6.3 Planning Scheme Amendment C417: Macaulay

1. Planning Scheme Amendment C417 (the Amendment) proposes changes to several provisions of the Melbourne Planning Scheme to enable the implementation of the objectives of the Macaulay Structure Plan 2021. The Structure Plan was endorsed by the Future Melbourne Committee in November 2021 following extensive community consultation.

5. Some changes are recommended to the amendment in response to submissions and officer review, including:
 - 5.1. A revised streets and laneways network.

Map 1: Building height

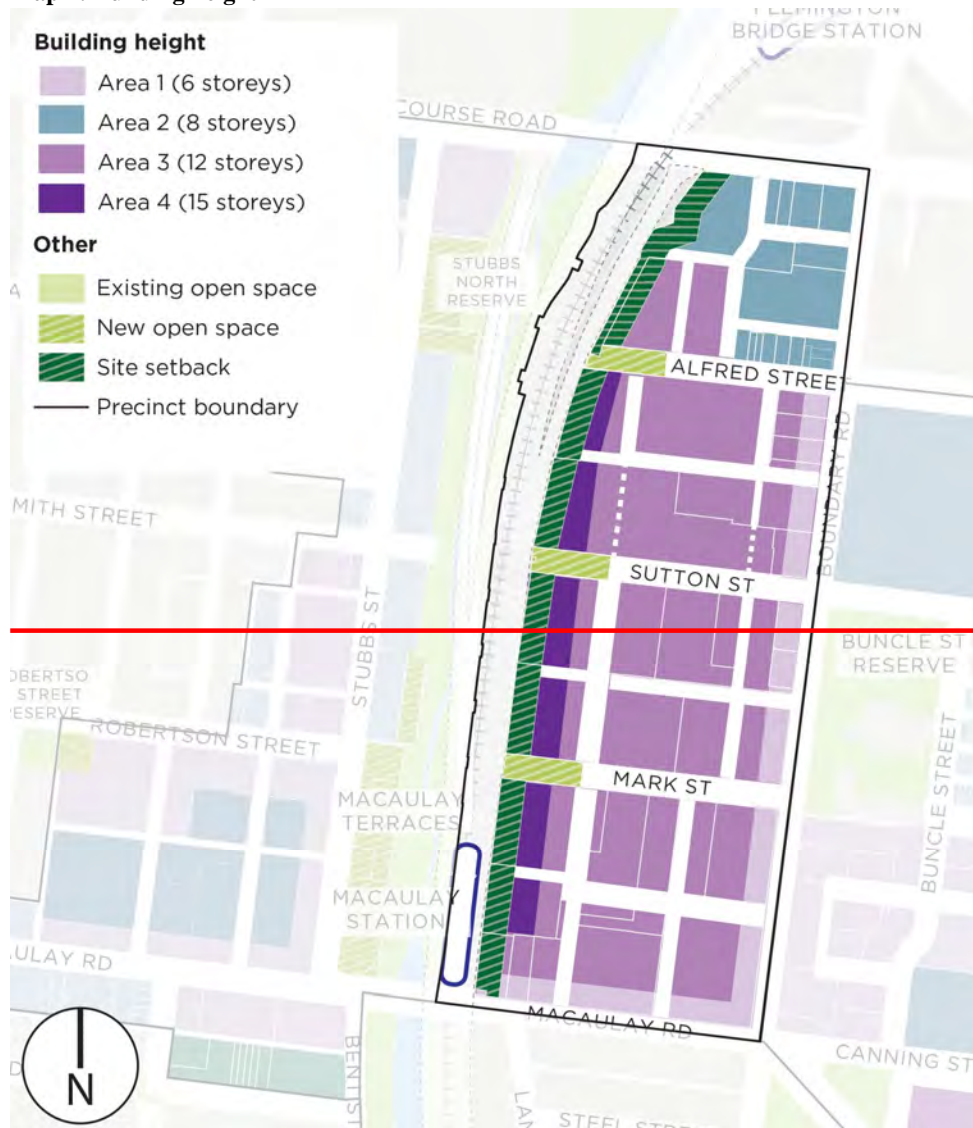
Buildings and works should not exceed the preferred maximum building height shown in Map 1 and as specified in Table 1 of this schedule.

Map 4: New streets, laneways and arcades

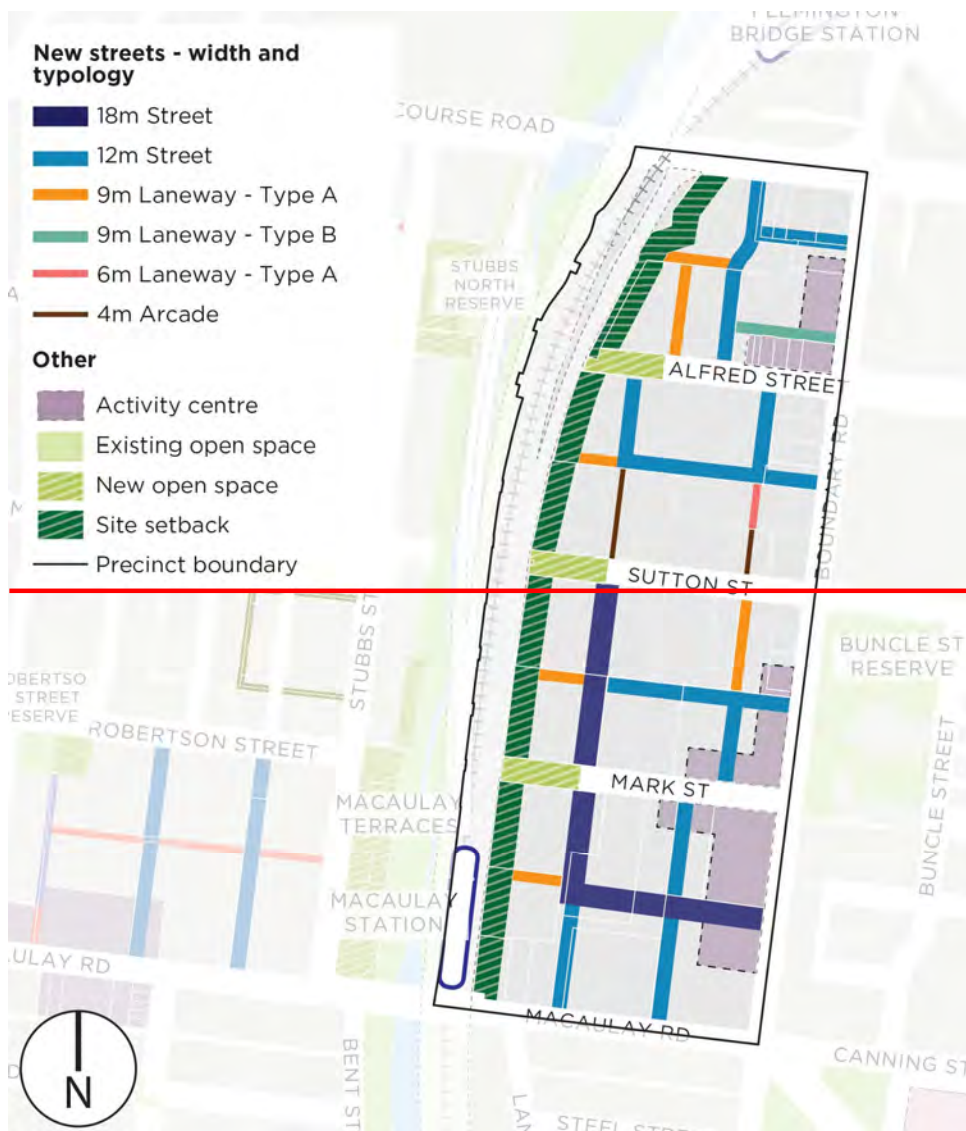
Development must provide for new public streets, laneways and arcades in accordance with Map 4 and the design requirements in Table 6.5.

Map 3: Site Moonee Ponds Creek setback

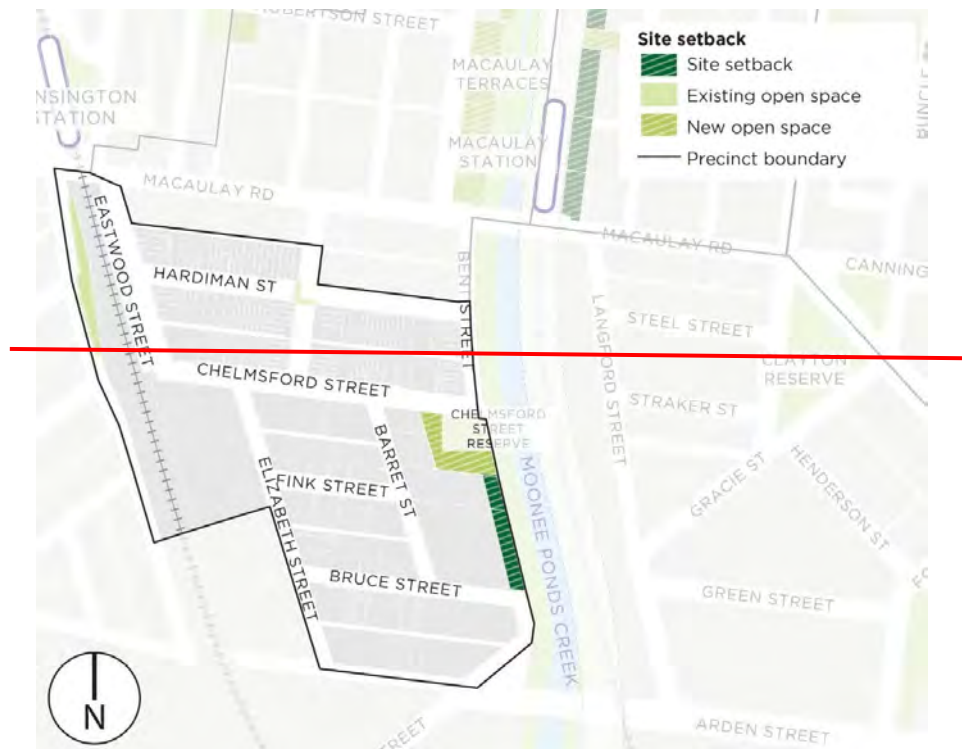
Buildings ~~and works~~ must have a minimum ~~site landscaped~~ setback as shown in Map 3 and specified in Table 2 of this schedule.

10m active transport corridor

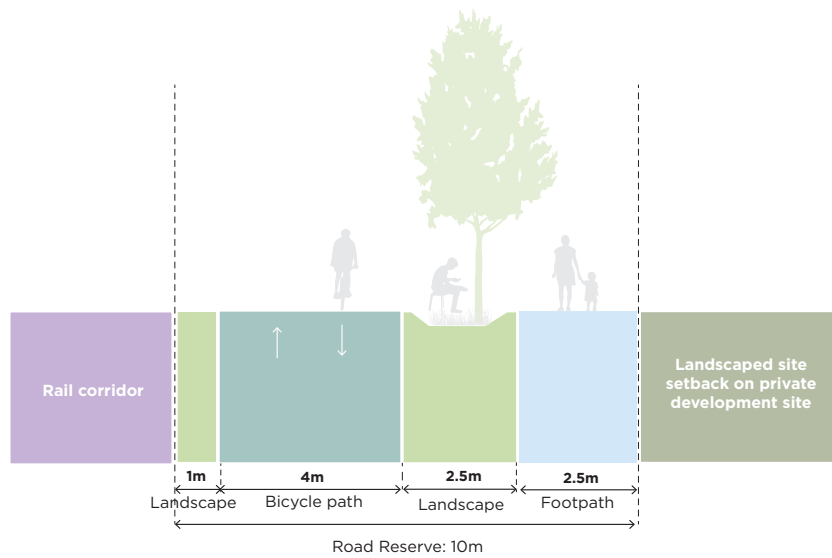
28. To help ensure delivery of the intended outcome, it is recommended that, in the case of the 20-metre setback in the Boundary Precinct, a 10-metre active transport corridor be delivered as a developer contribution funded project, with the remainder of the linear corridor width (10 metre) remains to be delivered as a mandatory built form setback. The implication for the Development Contributions Plan (DCP) is discussed further below.
